**TOWN AND COUNTRY PLANNING ACT 1990
(DEVELOPMENT MANAGEMENT PROCEDURE) (ENGLAND) ORDER 2015
ARTICLE 18 CONSULTATION WITH HIGHWAY AUTHORITY**

PROPOSAL: Two storey rear extension, new parking space with access alterations, elevation changes comprising replacement windows and doors with rendered external wall insulation to sides and rear elevations, dormer loft conversion and photovoltaic panels to front elevation.

LOCATION: Cotherstone High Lea Road
New Mills

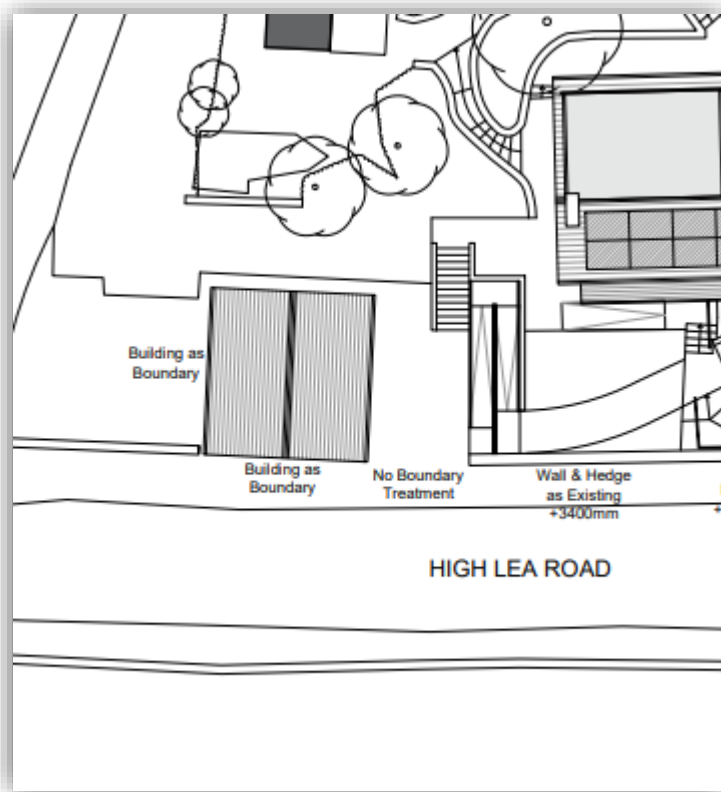
1. *'There are no changes to the proposed site layout. The proposed changes to car parking and ramped access do not alter the layout of buildings on the site. The alterations will improve visibility and connectivity to the garage enhancing natural surveillance and security.'*

However, based on the analysis of the information submitted, an explanation is required regarding the statement that the '*alterations will improve visibility*' and (see extract from submitted drawing 4121-00-12 A below), no visibility splays have been shown.

The County Council would wish to see the highway issue addressed prior to determination, however, should the LPA be minded approving the application in its current form we would be grateful if the LPA could reconsult the Highway Authority so that consideration can be given to formulating an appropriate response.
